**SUBDIVISION & PLANNED UNIT  
DEVELOPMENT STAFF REPORT****Date: September 17, 2015****NAME**

Pinehurst Villa Subdivision, Revised Lot 59

Subdivision approval to resubdivide lot and vacate public right-of-way; and Planned Unit Development to amend a previously approved Planned Unit Development to allow multiple buildings on a single building site and reduced side yard setbacks.

# SITE PLAN

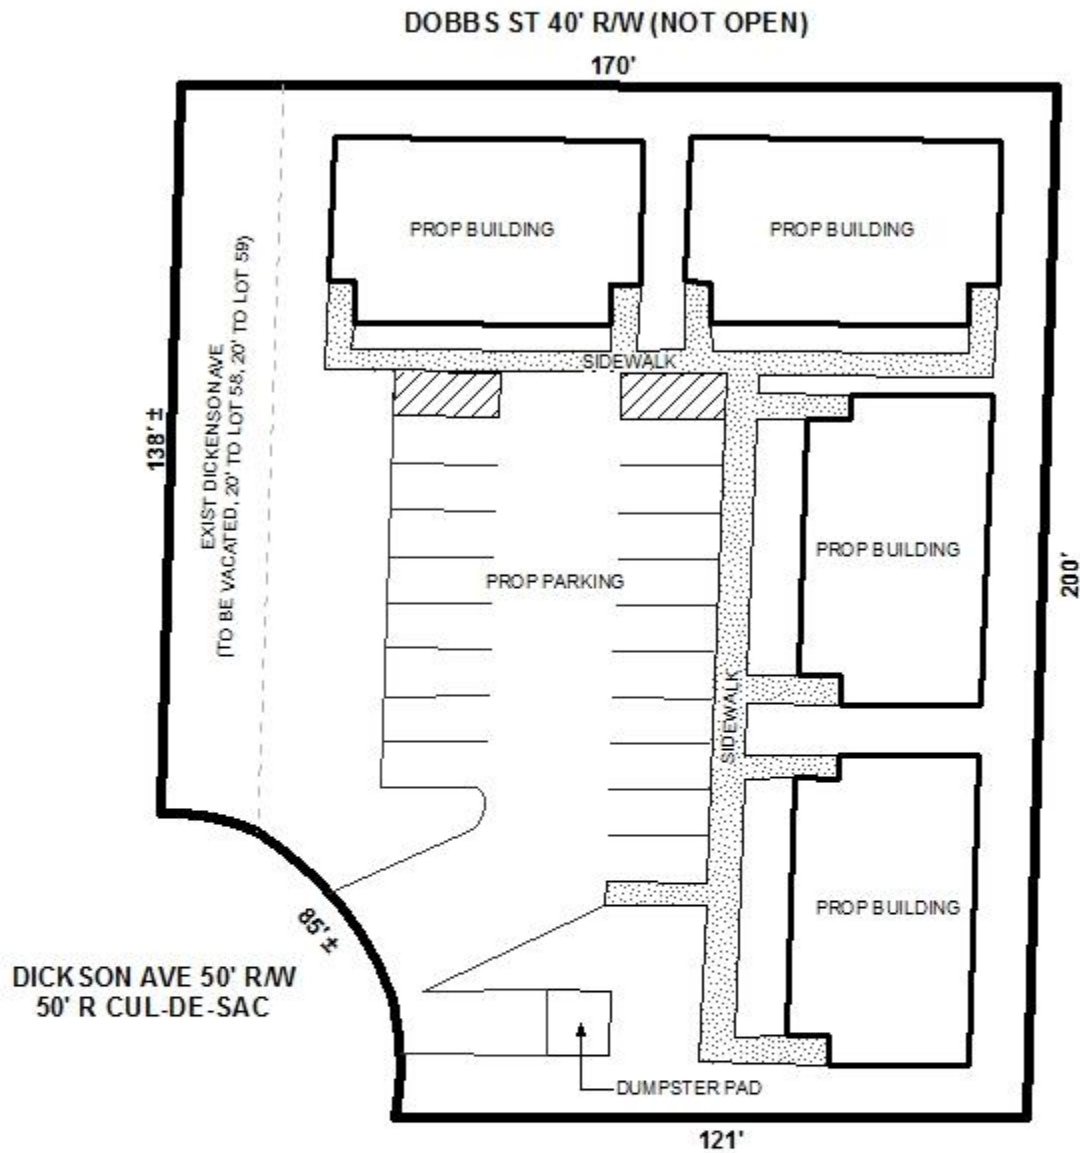
**Planned Unit Development:** 1. The existing drainage ditch along the north and west property lines will need to be shown (top of bank). 2. The applicant will need to provide a drainage easement for the existing drainage ditch that runs along the north and west property lines, and for the existing underground drainage system.

The proposed development appears to be compliant as it relates to site coverage; however, the site plan should be revised to illustrate compliant landscaping, tree, and parking calculations as required by Section 64-4.E of the Zoning Ordinance.

The 25' minimum building set back line is not clearly depicted on the site plan, and should be illustrated on the revised site plan, if approved. Also, the site plan should be revised to provide the lot size in square feet and acres.

The site plan illustrates that 18 parking spaces will be provided for the entire development in lieu of the 12 parking spaces required by the Zoning Ordinance. The site plan depicts a compliant number of parking spaces required for the site; however, no curbing or bumper stops are illustrated within the parking area. The site plan should be revised to indicate curbing or bumper stops within each parking space or provision of a note stating so. In addition to providing the required wheel stops and/or curbing for the parking spaces, the parking area must also provide lighting in compliance with Section 64-6.A.3 of the Zoning Ordinance.

The size and location of the mechanical equipment proposed for each residential unit must be depicted on the site plan and should ensure that it is compliant with Section 64-4.D.11 of the Zoning Ordinance.

The site plan illustrates that on site garbage collection will be served via a dumpster; however, the site plan should be revised to illustrate a connection to sanitary sewer in accordance with Section 64-4.D.9 of the Zoning Ordinance, or the placement of a note on the site plan indicating such.

The sidewalk is clearly depicted and labeled along the entrance to the property on Dickenson Avenue. If approved, the labeled side walk should be retained on the revised site plan. It should be noted that there do not appear to be any sidewalks along Dickenson Avenue.

As a means of access management, a note should be required on the revised site plan, if approved, stating that the PUD is limited to one curb cut to Dickenson Avenue, with the size, location and design to be approved by Traffic Engineering and conform to AASHTO standards.

- 1) Revision of the site plan to illustrate compliant landscaping, tree, and parking calculations as required by Section 64-4.E of the Zoning Ordinance;

- 2) Revision of the site plan to clearly illustrate the 25' minimum building set back;
- 3) Revision of the site plan to provide the lot size in square feet and acres;

- 4) Revision of the site plan to illustrate curbing or bumper stops within each parking space or provision of a note stating so;
- 5) Revision of the site plan to provide lighting within the parking area in compliance with Section 64-6.A.3 of the Zoning Ordinance.

- 6) Revision of the site plan to indicate the height and size of the HVAC mechanical equipment in compliance with Section 64-4.D.11 of the Zoning Ordinance;

- 7) Revision of the site plan illustrates that on site garbage collection will be served via a dumpster; however, the site plan should be revised to illustrate a connection to sanitary sewer in accordance with Section 64-4.D.9 of the Zoning Ordinance, or the placement of a note on the site plan indicating such. Retention of the sidewalk and labeling along the entrance to the proposed development along Dickenson Avenue;

- 8) Placement of a note on the revised site plan stating that as a means of access management, the PUD is limited to one curb cut to Dickenson Avenue, with the size, location and design to be approved by Traffic Engineering and conform to AASHTO standards;
